**DEFENSE NUCLEAR FACILITIES
SAFETY BOARD**

Staff Report

Date: March 21, 2024

Final Design of the Continuous Air Monitor (CAM) System for the Safety Significant Confinement Ventilation System (SSCVS) at the Waste Isolation Pilot Plant (WIPP)

Figure 1. Representative CAM Design (adapted from [11])

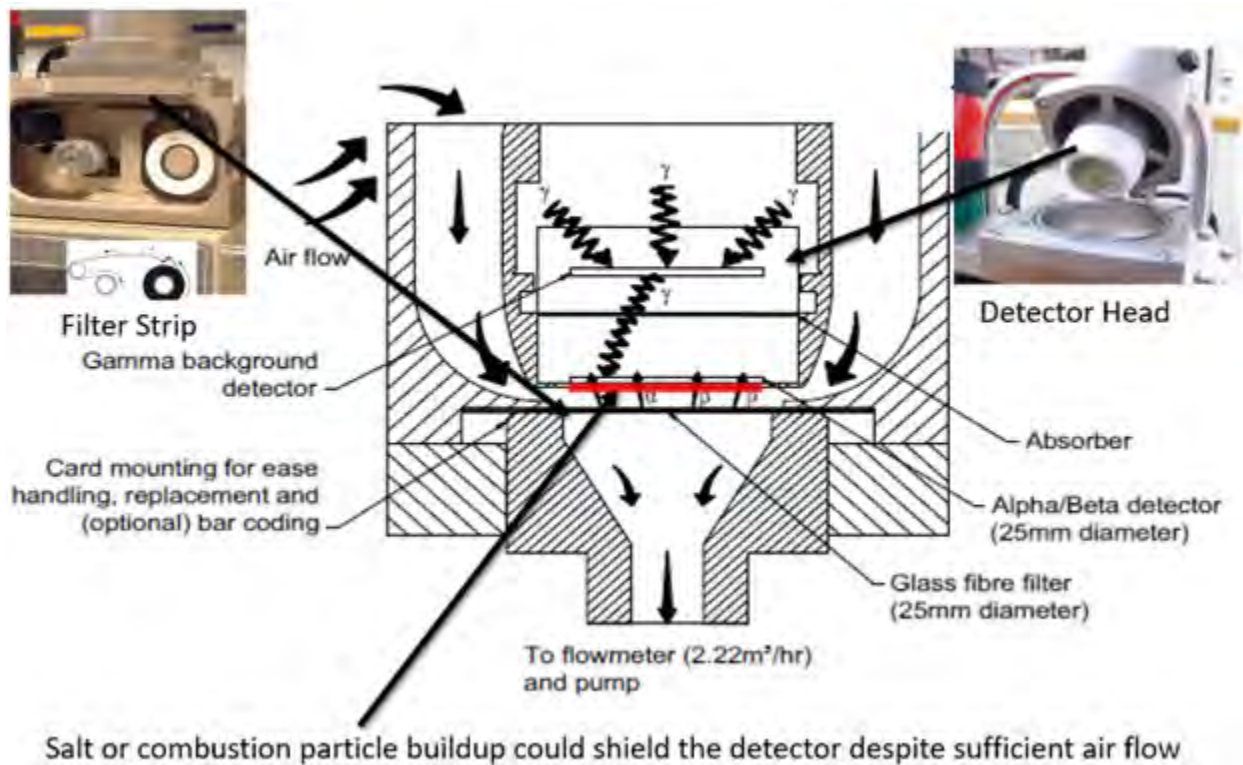
CAMs in the WIPP mine are subject to inflow of airborne salt particles. The CAMs are also required to perform their safety functions while being subject to a smoke-filled environment resulting from a postulated accident event that the safety instrumented system is designed to mitigate. Despite sufficient air flow, airborne particles of salt and combustion products may build up on the detector, shielding alpha and beta radiation from reaching the detector (Figure 1). This could affect the detector's performance before the accumulated particulate obstructs the airflow through the CAM sufficiently to trigger a protective action from the safety instrumented system to align SSCVS into a safe configuration to avoid a radiological release to the surface. This would impact the ability of SSCVS to perform its safety function. The magnitude of this shielding effect has not been evaluated or quantified. Even though the design uses a CAM array consisting of three separate CAMs, any of which can initiate the safety function, they are all subject to the same environment, which can serve as a potential common mode failure initiator.

SIMCO has maintained that the operating environment is not considered as part of the SIL analysis. This amounts to an assertion that the operating environment has no effect on component reliability. However, the environment in which the safety significant CAMs operate

could have a significant impact on their performance, as recognized in ANSI/ISA-84.00.01-2004.

The CAMs are the most robust version available from the manufacturer and have been fitted with titanium-clad detectors to better withstand the salt dust environment. But this does not mitigate the potential alpha and beta particulate shielding effects from particle buildup. The effects of the environment in which the CAMs operate should be further evaluated to ensure it will not affect performance of the CAMs' safety function. Ideally, this evaluation should be supported by test data.

Figure 2. Illustration of Underground Airflow

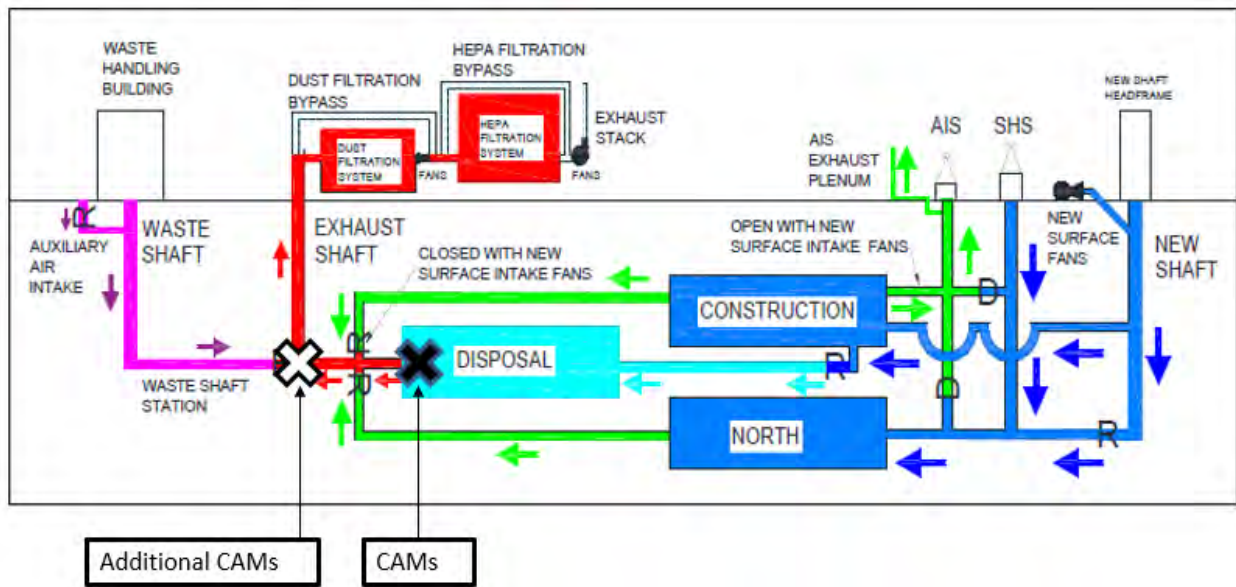
SSCVS is not used as a Safety Control to Mitigate Accidents at the Underground Waste Station—Transuranic waste is present at three main areas in the underground: (1) the waste shaft station during waste download; (2) the transport path while waste is being moved from the waste shaft station to the waste panel; and (3) the active waste (disposal) panel where the waste is permanently emplaced (Figure 2). Accident events with high consequences to the collocated worker have been identified in these three areas [1]. CAMs are located at the disposal panel. Additional CAMs could be located at the waste shaft station.

SIMCO will credit the initial condition [12], the administrative controls, and the engineered control to reduce the risk of postulated events along the transport path and at the waste panel. However, SIMCO only credits the initial condition and administrative controls for the waste shaft station (Table 1). DOE Standard 3009-2014 [2] establishes that due to the inherent uncertainty of human performance, engineered controls are preferred over administrative controls.

Crediting SSCVS/CAMs as an engineered control for accidents at the waste shaft station would require locating CAMs at the waste shaft station near bulkhead 308. It would also require a damper actuator capable of isolating the salt reduction system in 30 seconds or less [4] [13]. SIMCO confirmed that the damper’s actuator will be capable of isolating the salt reduction system in as little as five seconds [14].

Based on DOE’s preferred hierarchy of controls and the capability of the CAM system to perform this safety function at the waste shaft station, the omission of SSCVS/CAMs as a credited control for these potential accidents is inconsistent with DOE Standard 3009-2014.
